**The City of Lake Forest
Building Review Board Agenda**

Agenda Item 3
710 Green Briar Lane
Revisions to Previously Approved Plans

710 Green Briar Lane

Consideration of a request for revisions to previously approved plans for a new residence on a vacant lot.

SITE PLAN WITH PROPOSED IMPROVEMENTS

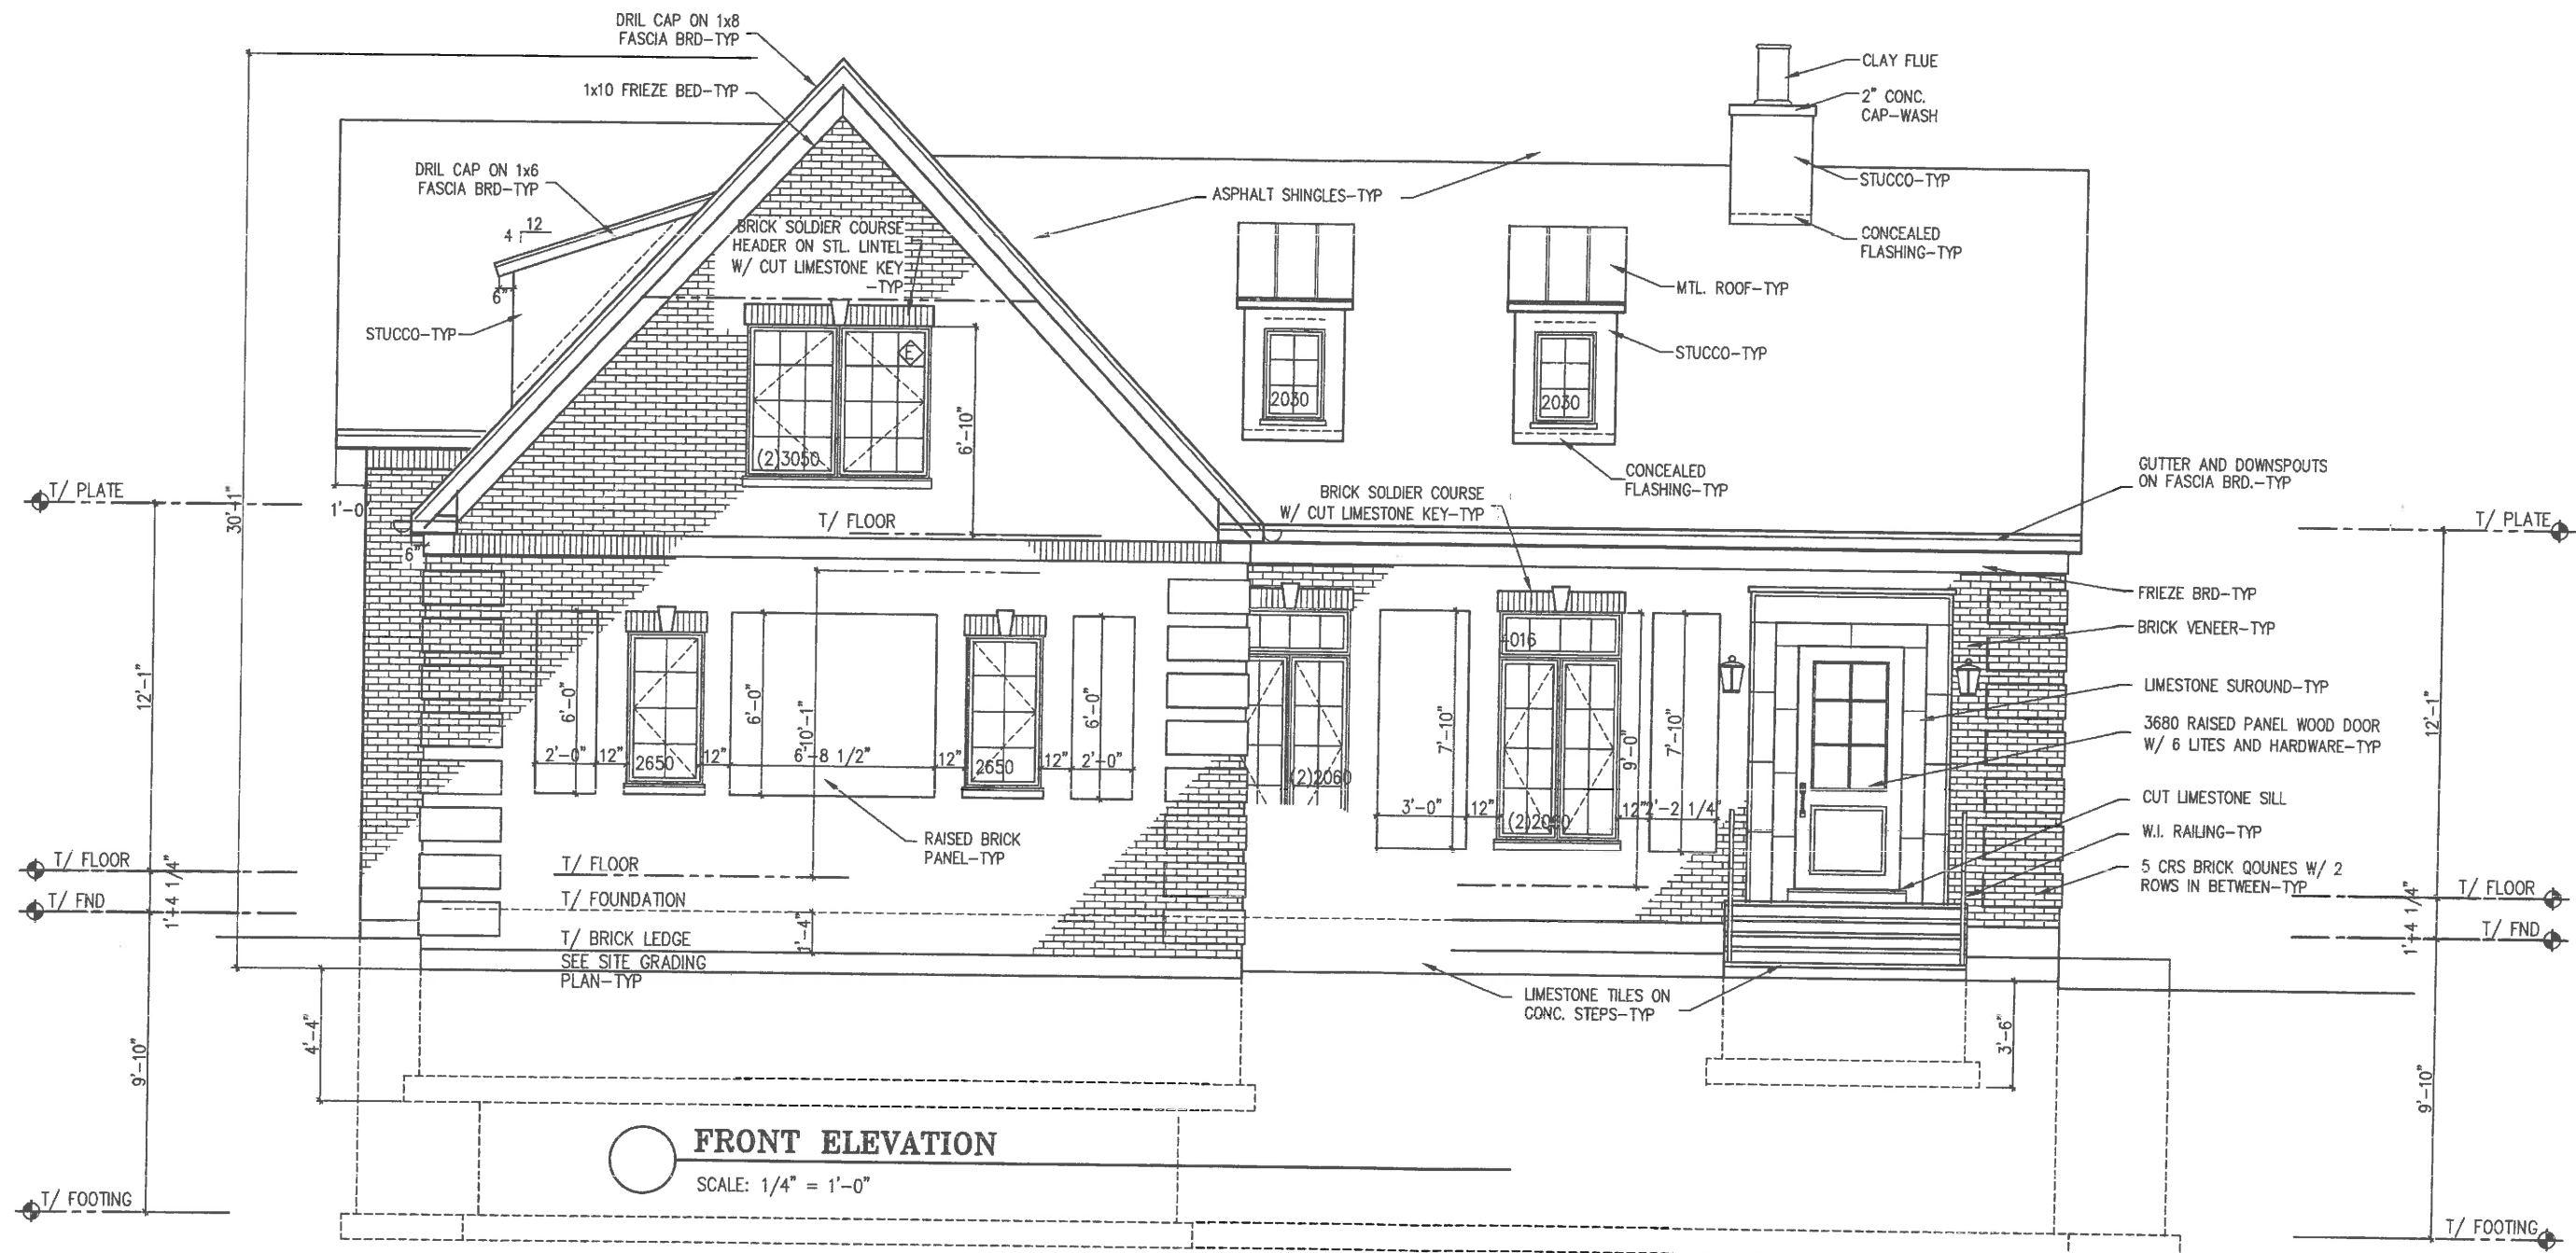
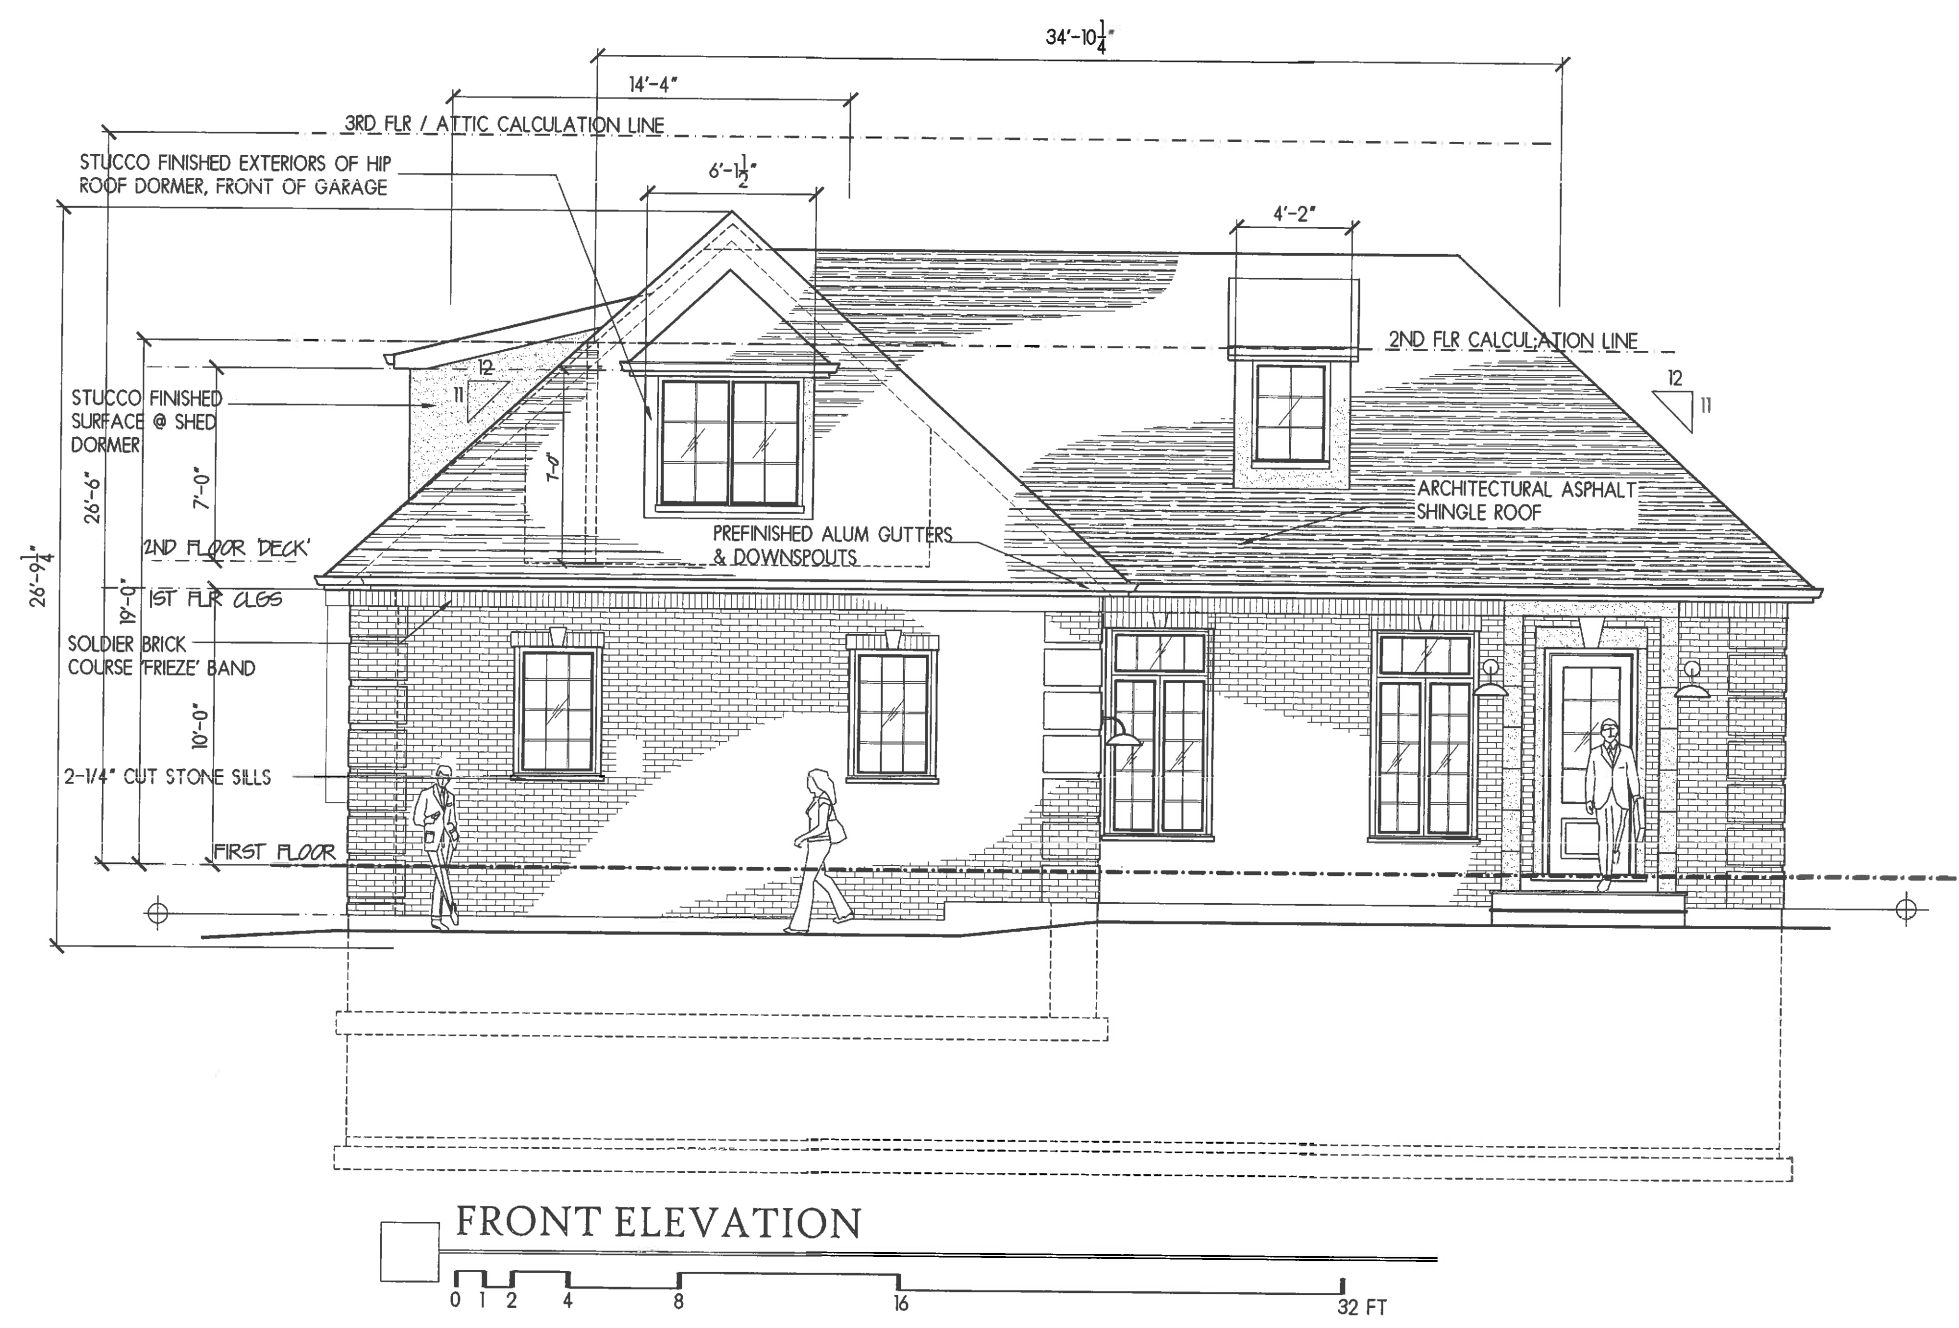
Site Plan

This standard is met. The plans as now proposed reflects a more compact building footprint. The garage element at the front of the house is shortened in the revised plan, the mudroom between the garage and house was removed. The location of the garage mass is consistent with the previously approved plans with the south wall of the garage. The main mass of the house is shifted approximately 16 feet closer to the front of the property. The driveway configuration is slightly different as reflected on the plans included in the Board's packet. The location of the curb cut remains the same as previously approved.

As noted in the previous discussions about this property, the City Engineer is well aware of some unique drainage issues in the area. A drainage easement will be required at the rear of the property to allow stormwater to continue to move through the property toward the Lake. Discussions about drainage with the neighbor to the east have occurred in the past, staff will share the updated drainage and grading plans with the neighbor and will be available to meet on site if desired.

FRONT ELEVATION

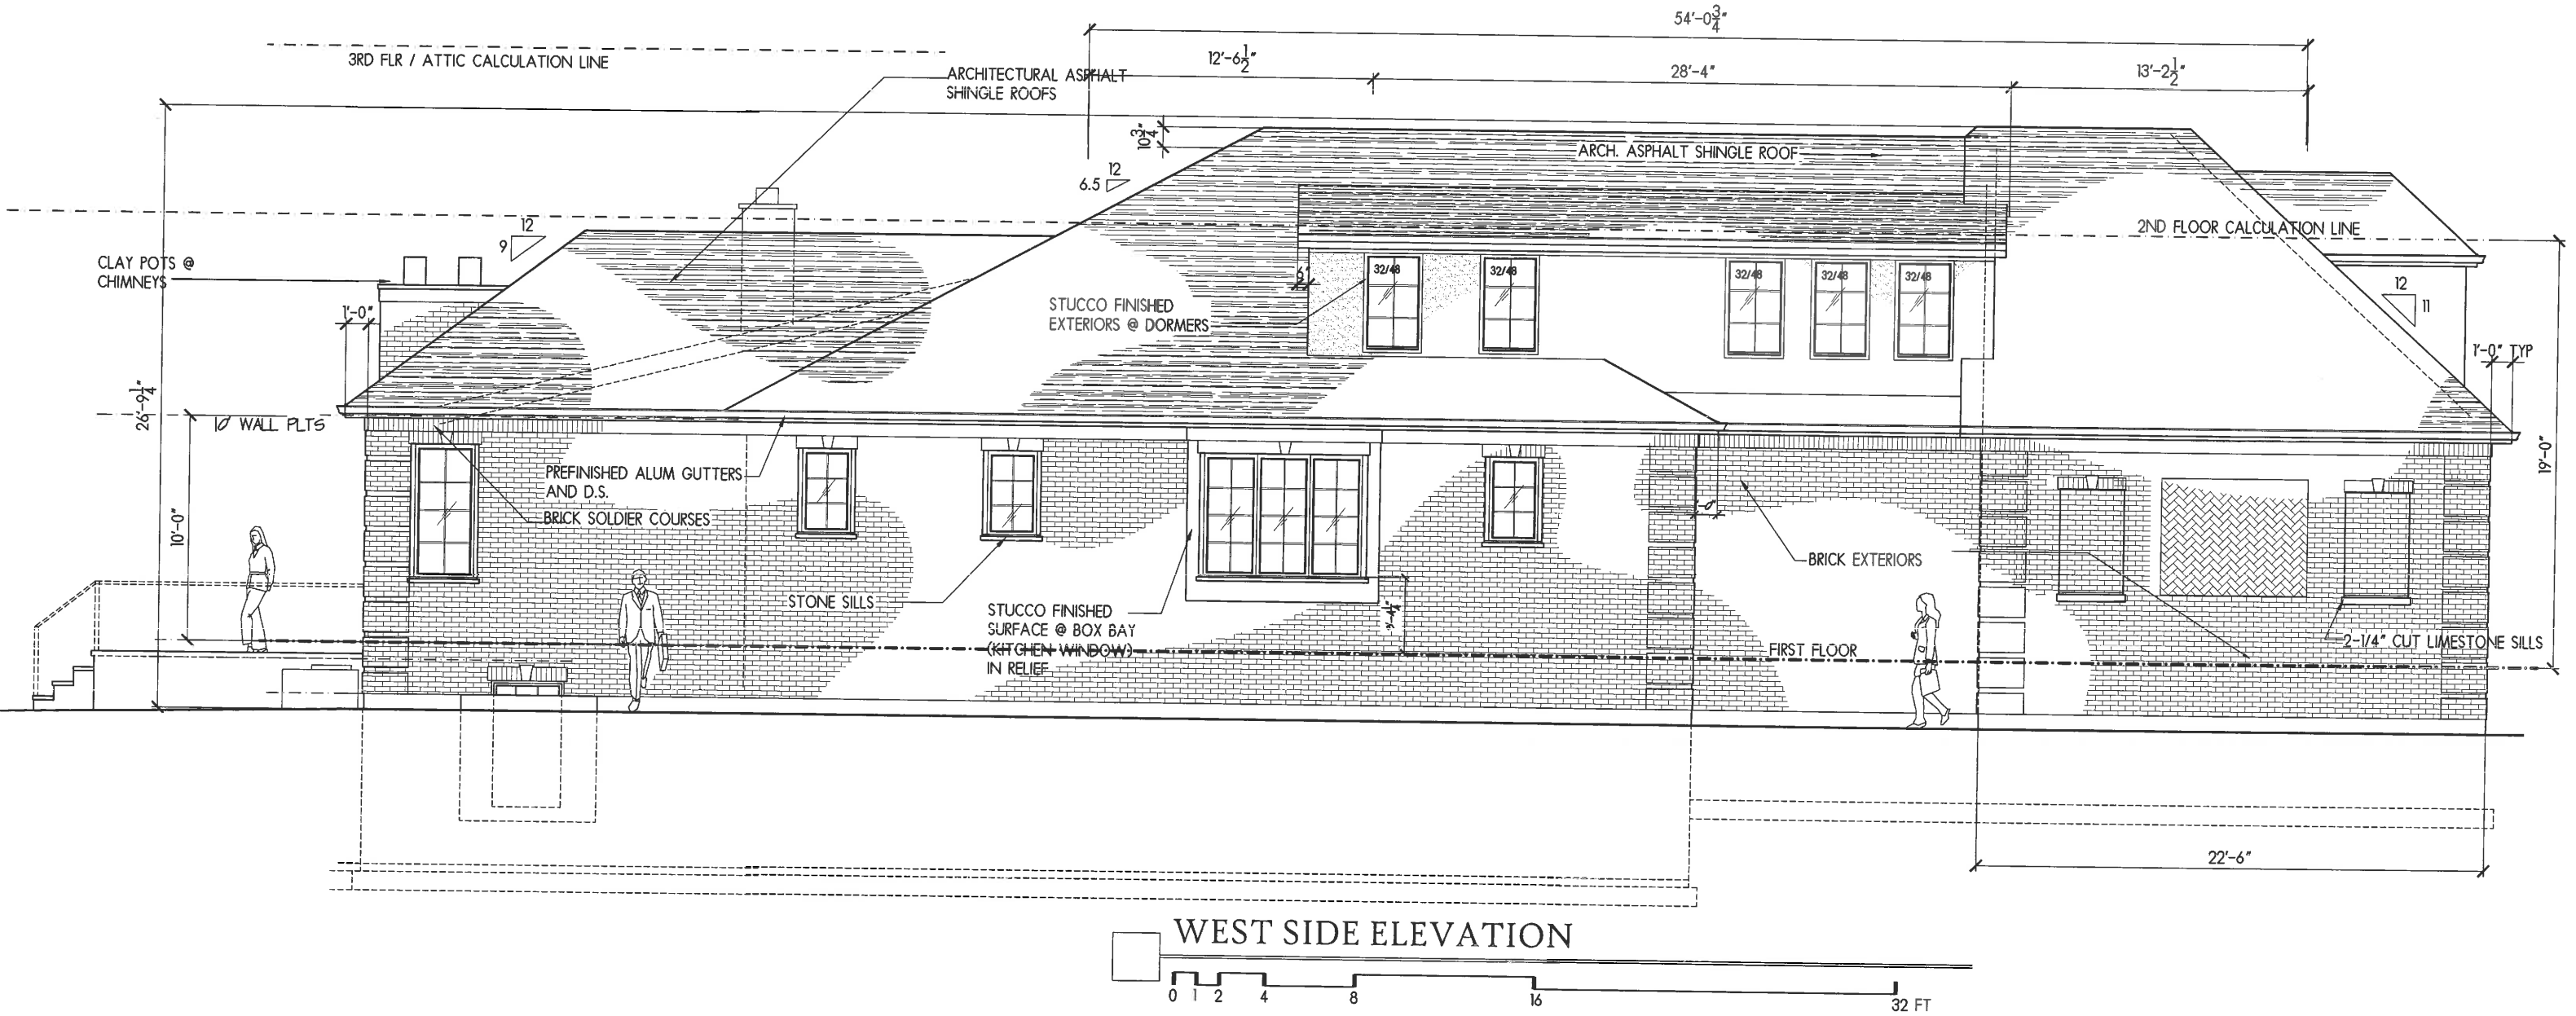
South (Front) Elevation

- Hip roof forms are now proposed on the garage mass and on the main mass of the residence to replace the previously proposed gable roof forms.
 - As currently proposed, the proportions of the hip roofs appear squat. The previously approved gable roof forms appeared more in keeping with the style, scale and proportions of the house. Board input on the hip roof forms is requested.
- A hip dormer with a double window is now proposed above the garage.
- One of the shed dormers was removed and a single dormer is now proposed on the main roof form and centered between the windows below.
- The detailing and proportions of the front entry door surround were modified.
- The proportions of the windows on the garage mass were modified.

- A. The plans shall be refined as follows:
 - a. An effort shall be made to simplify the overall roof form and reduce the number of different roof pitches.
 - b. The fenestration pattern shall be studied further in an effort to present a more regular pattern across all elevations of the home.
 - c. Brick shall be used for all chimneys.
 - d. Any additional items as directed by the Board.
- B. The plans submitted for permit shall be fully detailed with respect to architectural elements, dimensions and exterior materials.
